**ADMINISTRATIVE INFORMATION****FMI No: 22904/22905****FMI Title: NGPDU Series Overheat Protection Replacement**

FMI No.: 22904/22905 FMI Title: NGPDU Series Overheat Protection Replacement

PURPOSE:

Figure 2 - Remove the Signal Cable

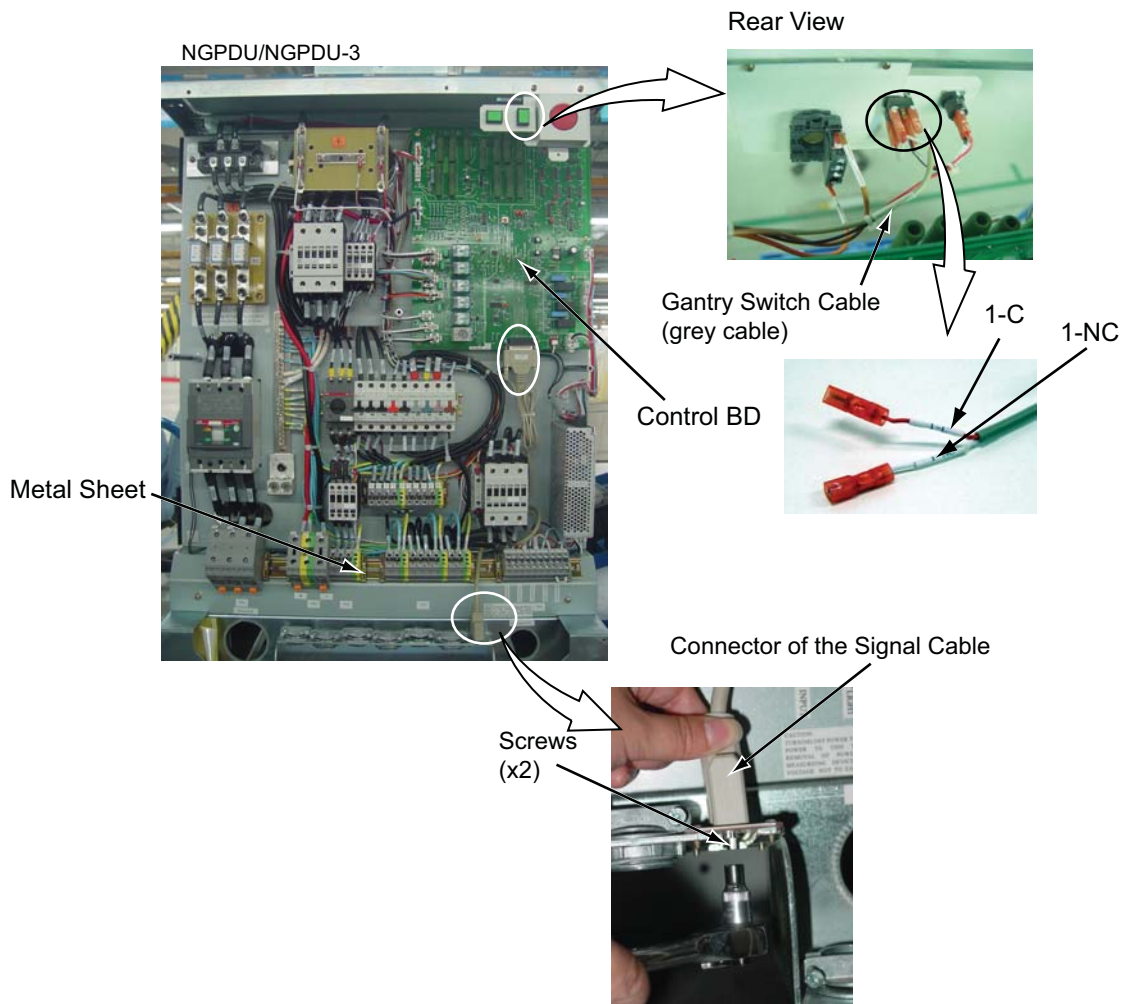
- 1.) Remove the old signal cable. (connectors within white circles)

- i.) Carefully remove the connectors of signal cable from the Gantry Switch, avoid causing damage to the cable or the Gantry Switch. (See [Figure 2](#))

- ii.) Remove the connector of signal cable from the PDU Control Board. (See [Figure 2](#))
- iii.) Remove the connector of signal cable from the metal sheet by unscrewing its two screws with 5mm socket wrench. (See [Figure 2](#))

Figure 3 - Install the Temperature Sensor

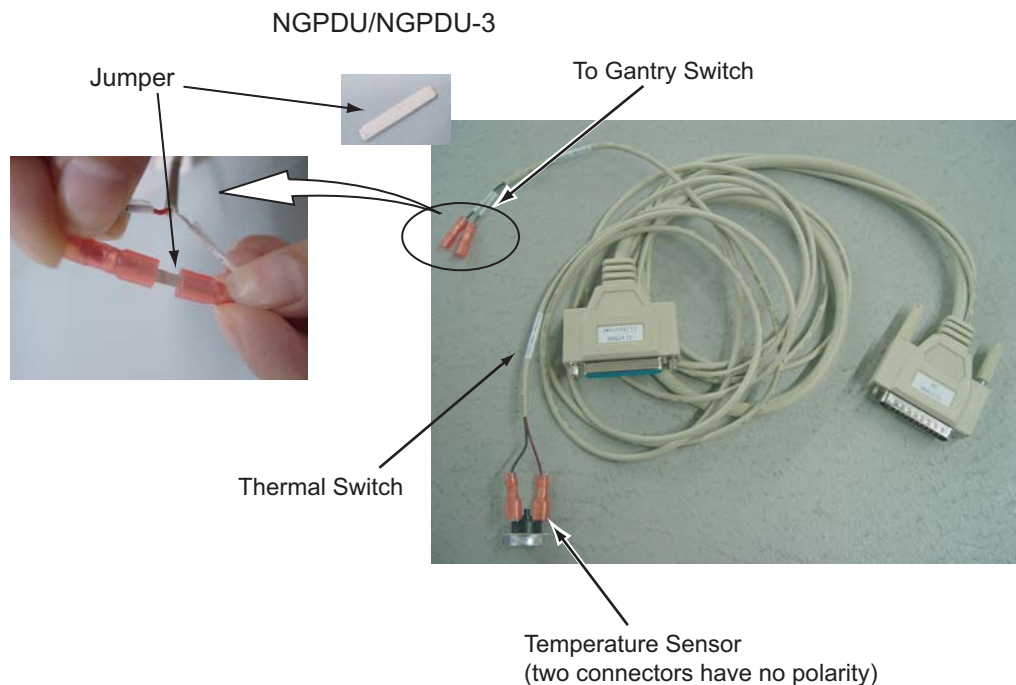
- 2.) Connect the Temperature Sensor to the end of the thermal switch of the new signal cable.
- 3.) For NGPDU/NGPDU-3 without the Gantry Switch, short the two connectors together with the jumper (5151248) provided with the FMI kit (5148582).

Figure 4 - Route the Signal Cable and fix the Temperature Sensor on the metal sheet

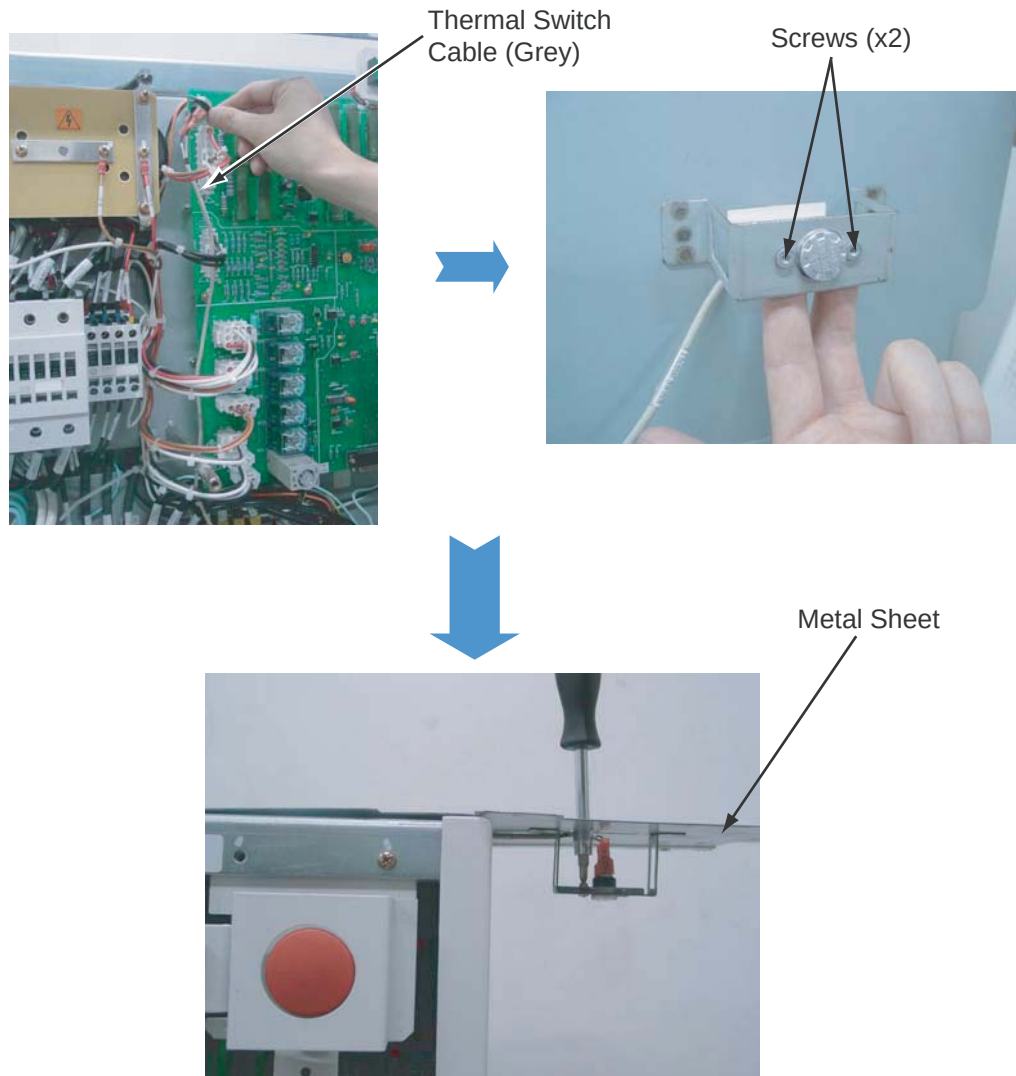
- 4.) Pull the Thermal Switch Cable to go through the wires from the bottom up. (See [Figure 4](#))
- 5.) Place the Temperature Sensor on the bracket of the metal sheet (5146322). (See [Figure 4](#))
Fasten two screws on the Temperature Sensor.

Figure 5 - Intall the metal sheet

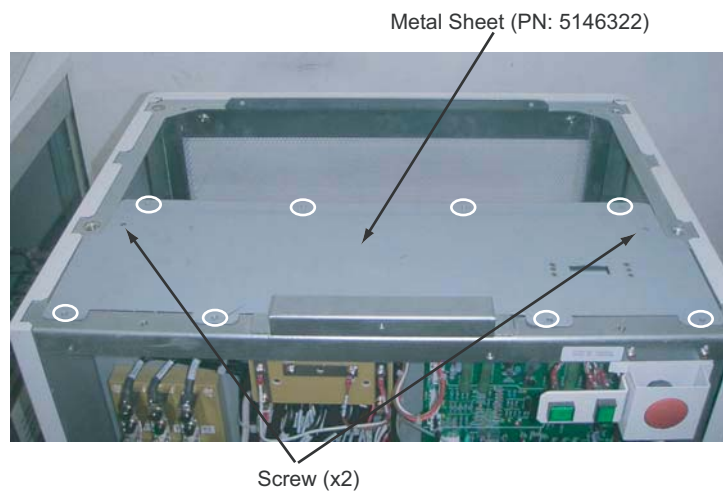
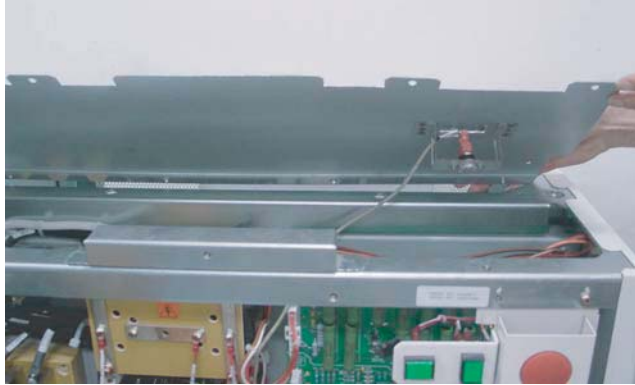
- 6.) Put the sheet metal (5146322) onto the top of the NGPDU/NGPDU-3. (See [Figure 5](#))

NOTICE Do not install the two screws (shown as [Figure 5](#)) at this time.

Note: For this FMI, eight holes (white circles in above figure) are unused.

Figure 6 - Install the Signal Cable

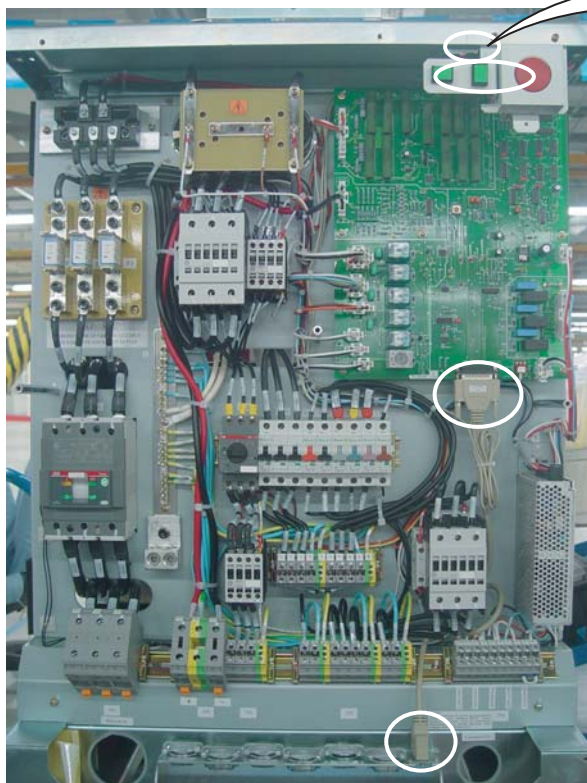
- 7.) According to [Step 1](#) process of remove the old Signal Cable in its reverse order to connect the new Signal Cable, then use tie-wraps to hold the cable. (See Illustration [Figure 6](#))

For NGPDU/NGPDU-3 without the Gantry Switch, pay attention to bind the Gantry Switch Cable.

Figure 7 - Remove the Signal Cable

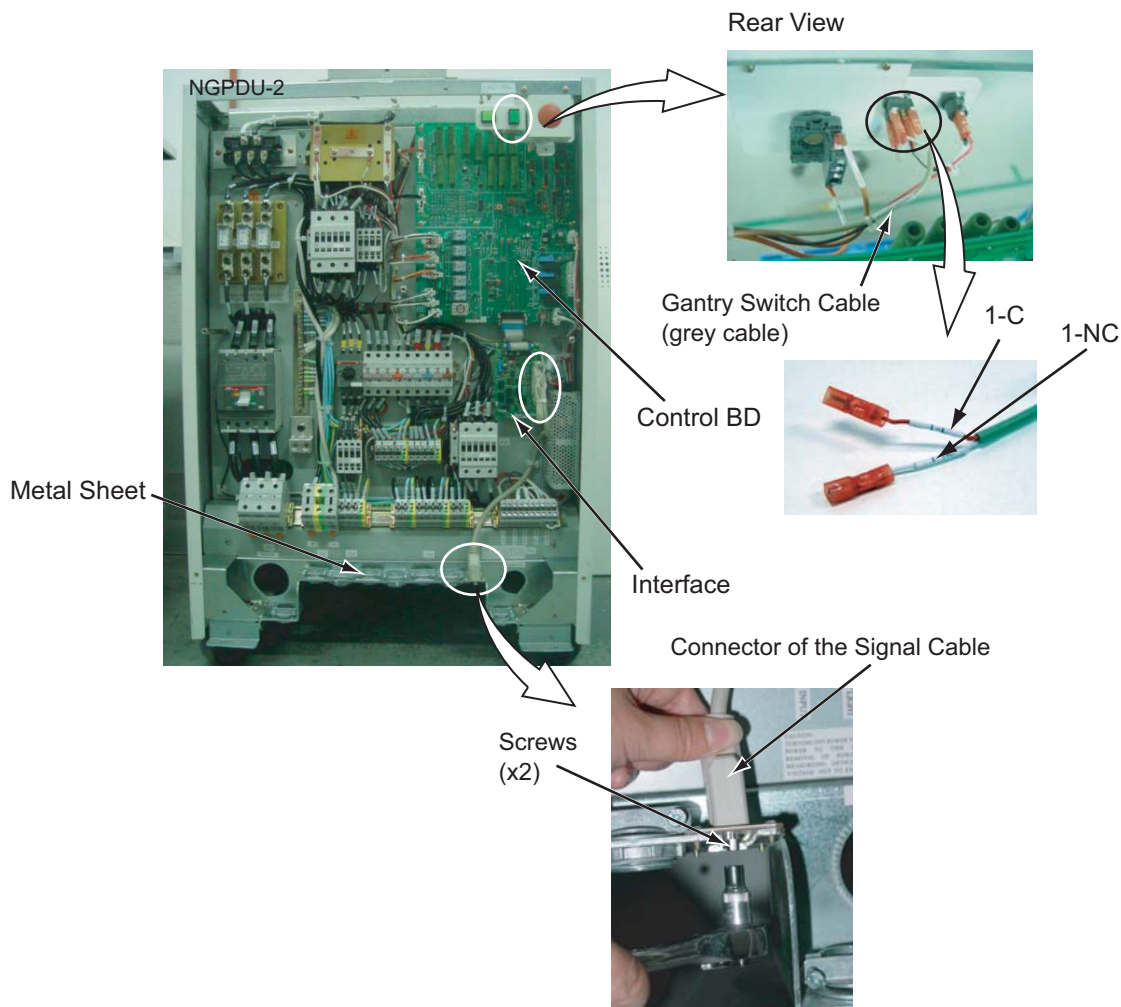
- 1.) Remove the old signal cable. (connectors within white circles)

- i.) Carefully remove the connectors of signal cable from the Gantry Switch, avoid causing damage to the cable or the Gantry Switch. (See [Figure 7](#))

- ii.) Remove the connector of signal cable from the Interface. (See [Figure 7](#))
 - iii.) Remove the connector of signal cable from the metal sheet by unscrewing its two screws with 5mm socket wrench. (See [Figure 7](#))

Figure 8 - Install the Temperature Sensor

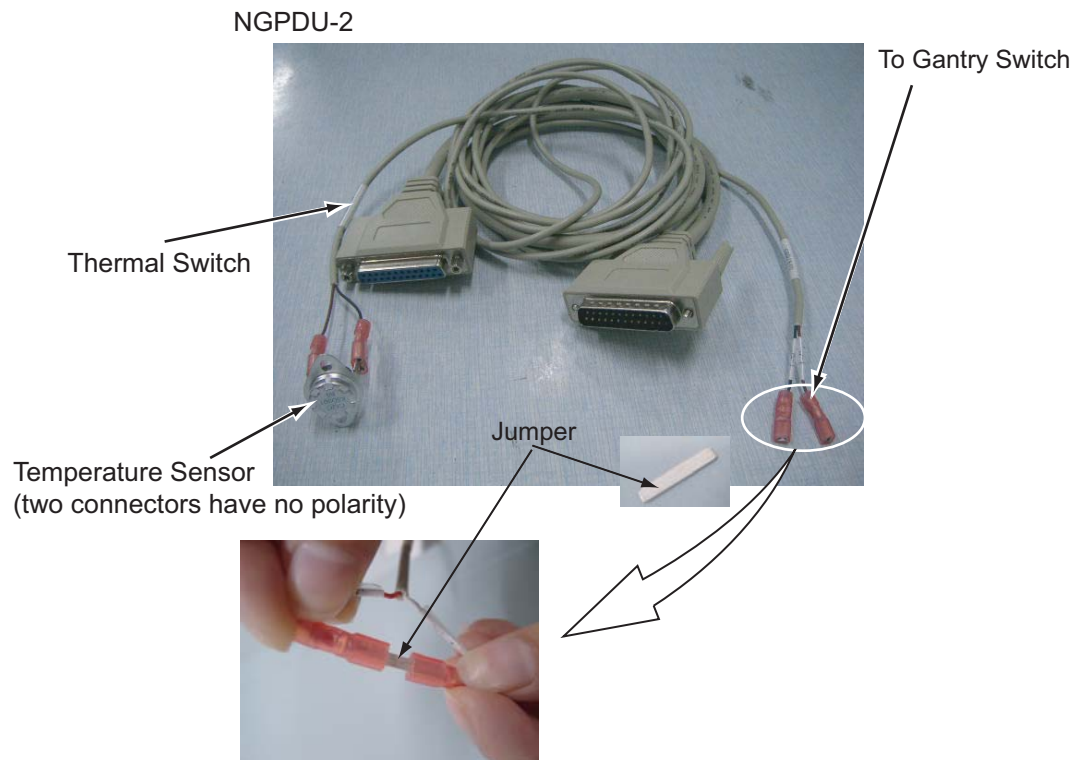
- 2.) Connect the Temperature Sensor to the end of the thermal switch of the new signal cable.
- 3.) For NGPDU-2 without the Gantry Switch, short the two connectors with the jumper (5151248) provided with the FMI kit (5151225).

Figure 9 - Install the Signal Cable

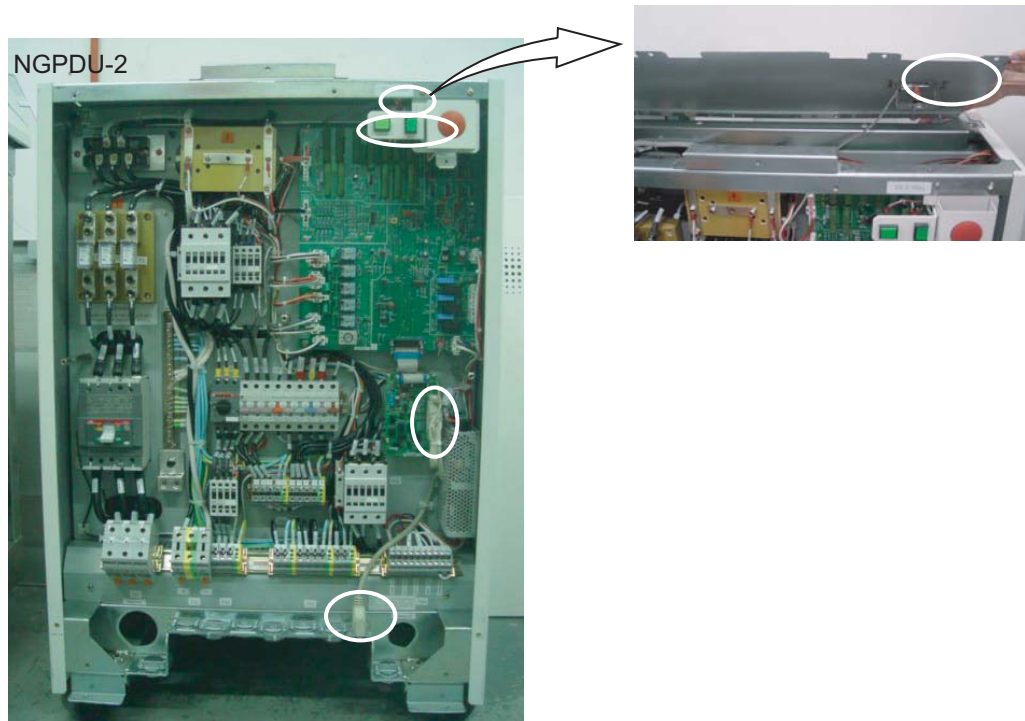
- 7.) According to [Step 1](#) process of remove the old Signal Cable in its reverse order to connect the new Signal Cable, then use tie-wraps to hold the cable. (See Illustration [Figure 9](#))

NOTICE For NGPDU-2 without the Gantry Switch, pay attention to bind the Gantry Switch Cable.
